**February 2, 2023**

## **PLANNING REVIEW CHECKLIST**

**Subject Property:** 3985 Lindburg Road SE  
**Reference Nos.:** 22-125120-PLN  
(Class 3 Site Plan Review, Class 2 Adjustment, & Class 2 Driveway Approach Permit)

1 SITE PLAN  
SCALE: 1"=20'-0"

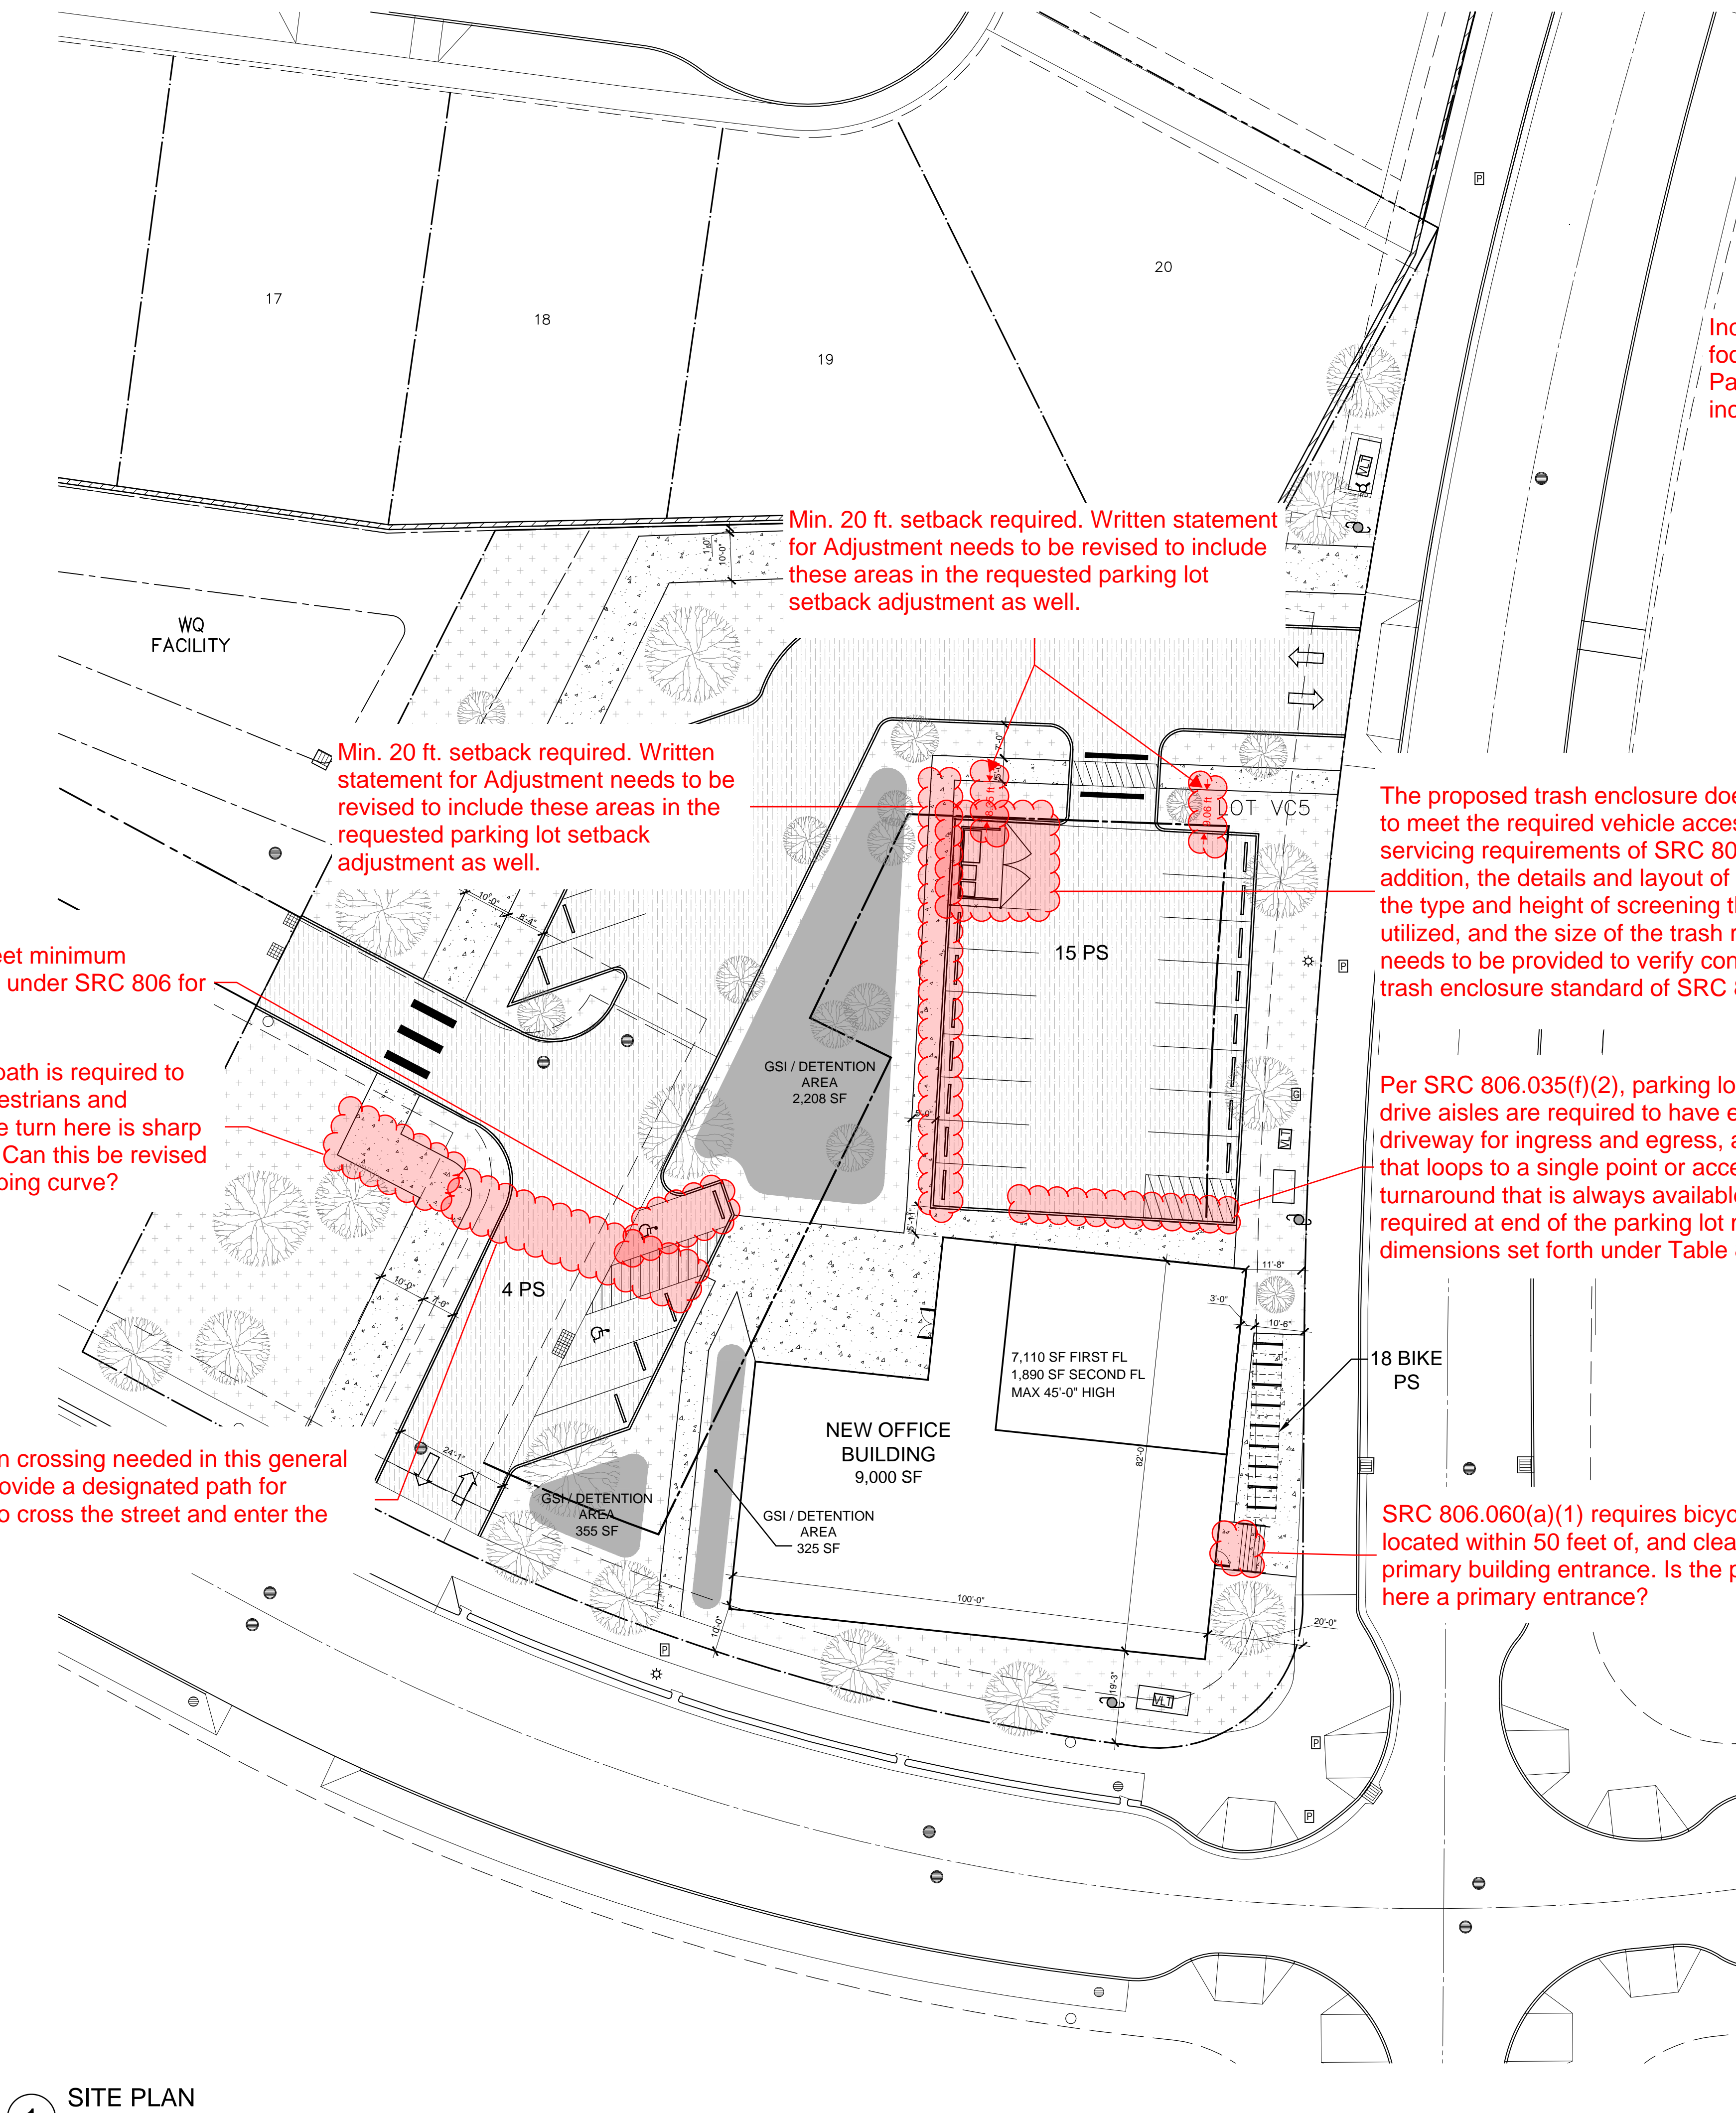
<b>Confirmation of Proposed Use</b>	The applicant for the proposed development is the Reid Saunders Association and the site plan indicates that the proposed use of the site is for an office use. Confirmation is needed that the proposed use is for office rather than religious assembly.
<b>Site Plan</b>	<p>The site plan needs to be revised to address the following:</p> <ul style="list-style-type: none"> <li>▪ <u>Property dimensions.</u> Per SRC 220.005(e)(1)(A)(i), site plans are required to include the dimensions of the property. The site plan submitted currently doesn't identify the exterior dimensions of the property. The site plan needs to be revised to show the exterior property dimensions.</li> </ul>
<b>Building Elevations</b>	Pursuant to SRC 220.005(e)(2)(A) and SRC 220.005(e)(1)(E), building elevation drawings are required for any proposed new buildings. No building elevation drawings have been provided but are required.

<b>Transit Improvements</b>	The Salem-Keizer Transit District ( <i>Cherriots</i> ) provided comments regarding required transit improvements along Lindberg Road and Strong Road as part of the prior pre-application conference held to discuss the proposed development (Pre-Application Conference Case No. PRE-AP22-12). A copy of those comments are provided for reference. In review of this site plan, the location of the required

Item:	Description:
	transit stops have not been identified. The site plan needs to be revised to show how the two required transit stops will be provided.
<b>Class 2 Adjustment – Parking Lot Setbacks</b>	<p>The proposed surface parking lot does not meet the minimum required 20-foot setback from Lindburg Road or from the proposed internal street. A Class 2 Adjustment has been requested for the required 20-foot setback abutting Lindburg Road, but not abutting the private street. Staff feels that an adjustment can be supported between the parking lot and the private street, but based on the information currently provided it is not clear that staff can support the requested parking lot setback adjustment adjacent from Lindburg Road unless it can be demonstrated that the proposed development equally or better meets the underlying purpose of the standard.</p> <p>One way the underlying purpose of the standard could be equally or better met is by providing a 3-foot-tall decorative screening wall between the parking lot and the street to provide additional vertical visual screening of the parking lot to offset the reduced setback depth.</p>

<b>Additional Comments on Plan</b>	<p>Please see the additional comments included on the attached site plan.</p>

Far-side boarding bulb stop example for the bus stop on Strong Rd:

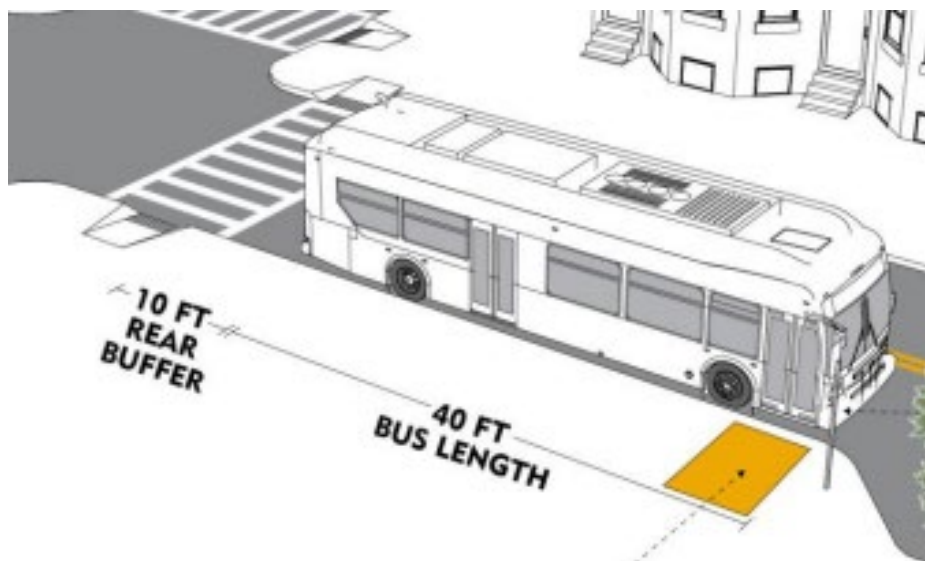
**COMMENTS:** Cherriots is exploring options to connect the new businesses and residences in the former Fairview Training Center site with south Salem, southeast Salem, and downtown Salem via public transportation and transportation options. The first step in realizing those connections is to establish bus stops in a centralized area that would see the most use. The office building in this application will host employees and customers, and is located in the heart of the Fairview Refinement area. Therefore, Cherriots requests two ADA compliant bus stops to be included in the plans for this development – one stop on Strong Rd for a bus traveling in the westerly direction and one stop on Lindburg Rd for a bus traveling in the southerly direction. The approximate locations are identified in the screenshot on the next page. The bus stop on Strong Rd should be located 50 feet from the stop line or crosswalk at the intersection with Lindburg Rd. The bus stop on Lindburg Rd should be located no less than 10 feet from the stop line or crosswalk at the intersection with Strong Rd. Because of the separated sidewalks, both bus stops will require a 6 foot by 8 foot boarding area at the front door of the bus as well as a landing pad at the rear door of the bus in order to bridge the planter strip/storm water ditch between the curb and sidewalk. Attached are three basic design examples for reference. Alternatively, the bulb-out design of the curb ramps at the intersection could be extended back from the from the curb ramps approximately 50 feet to create boarding bulb bus stops. Screenshots of boarding bulb bus stop examples are also included on the following pages.

## Existing Sidewalk (Option 1 – Sidewalk Separated from Curb)

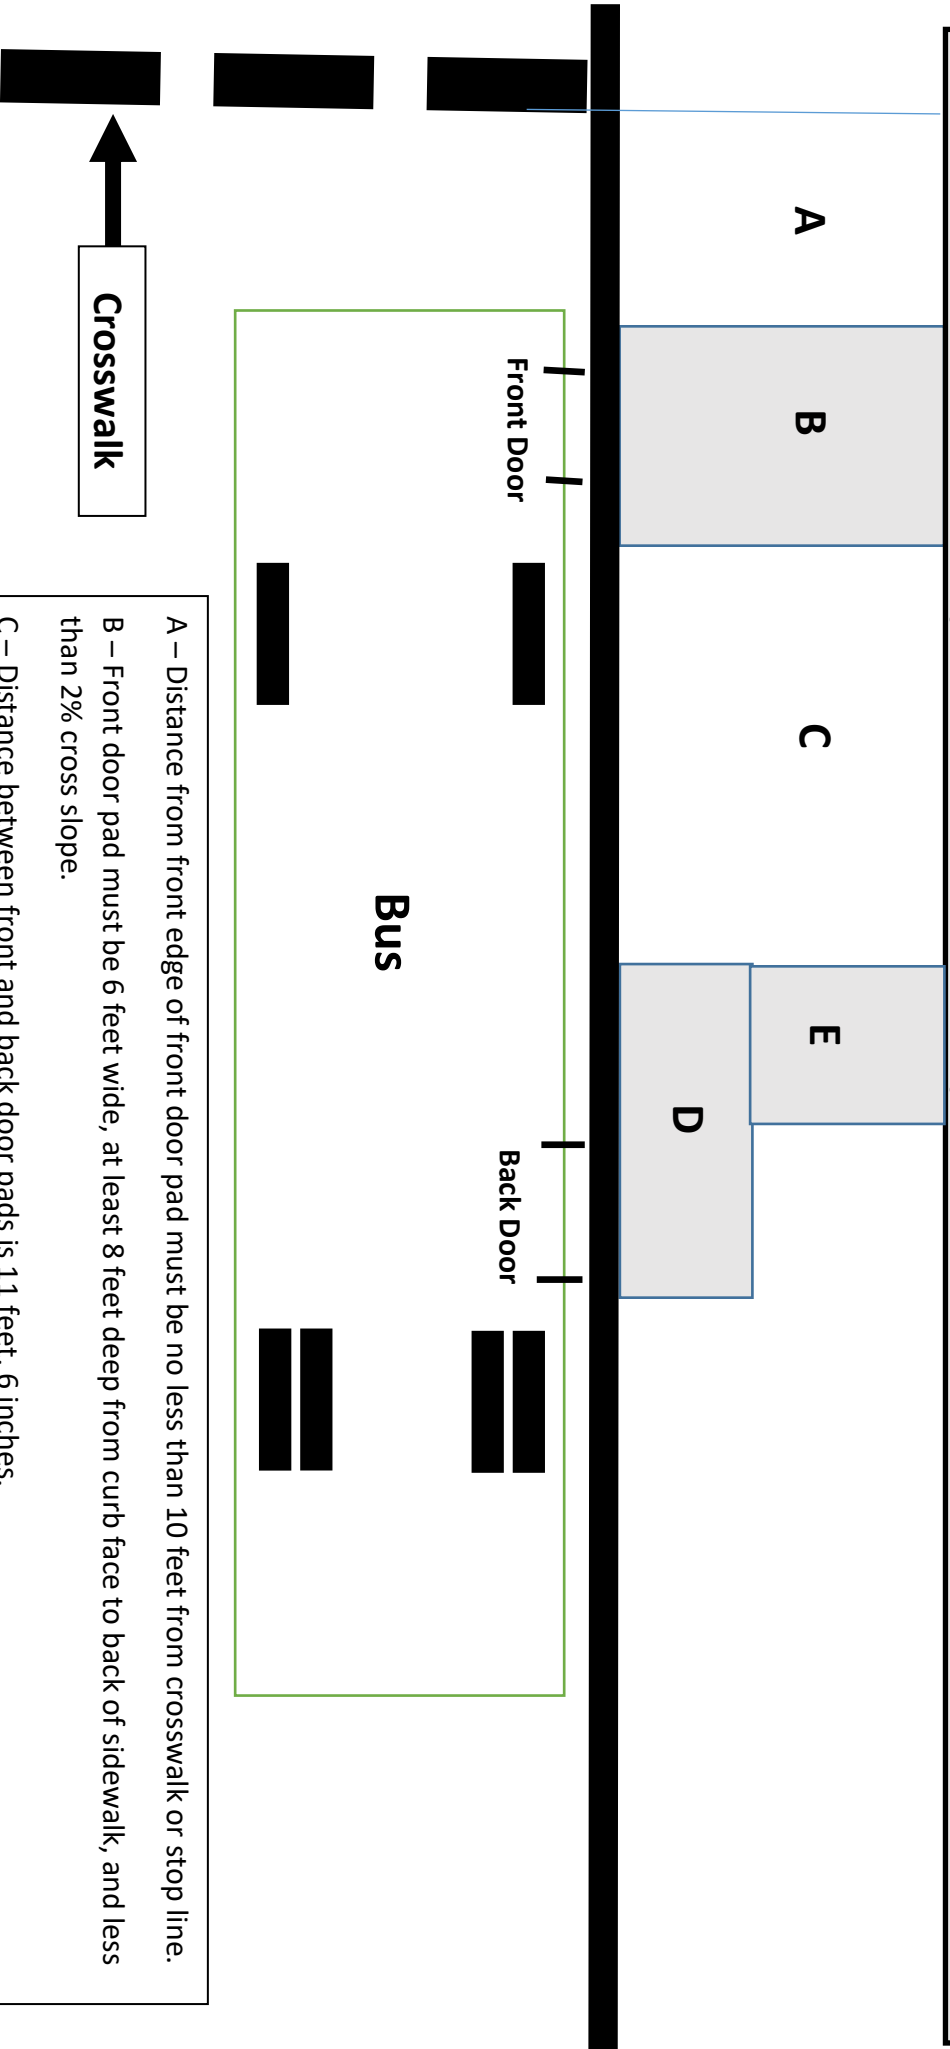
A – Distance from front edge of front door pad must be no less than 10 feet from crosswalk or stop line.

B – Front door pad must be 6 feet wide, at least 8 feet deep from curb face to back of sidewalk, and less than 2% cross slope.

C – Distance between front and back door pads is 11 feet, 6 inches.

D – Rear door pad must be 10 feet wide and 5 feet deep.

E – A connecting pad at least 5 feet wide to connect the door pad to the sidewalk with less than 2% cross slope.

## Existing Sidewalk (Preferred Design / Sidewalk Separated from the Curb)

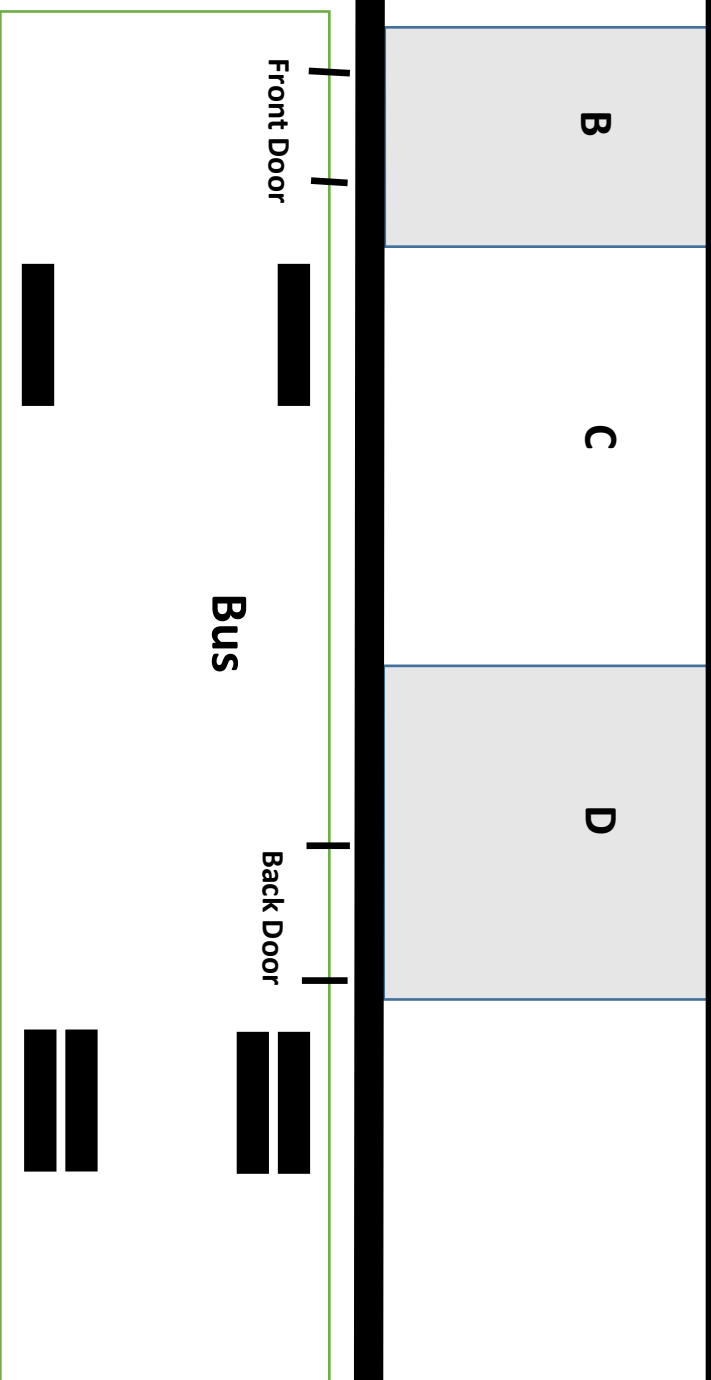
- A – Distance from front edge of front door pad must be no less than 10 feet from crosswalk or stop line.
- B – Front door pad must be 6 feet wide, at least 8 feet deep from curb face to back of sidewalk, and less than 2% cross slope.
- C – Distance between front and back door pads is 11 feet, 6 inches.
- D – Rear door pad must be 10 feet wide and the same depth and slope requirements for the front door pad.
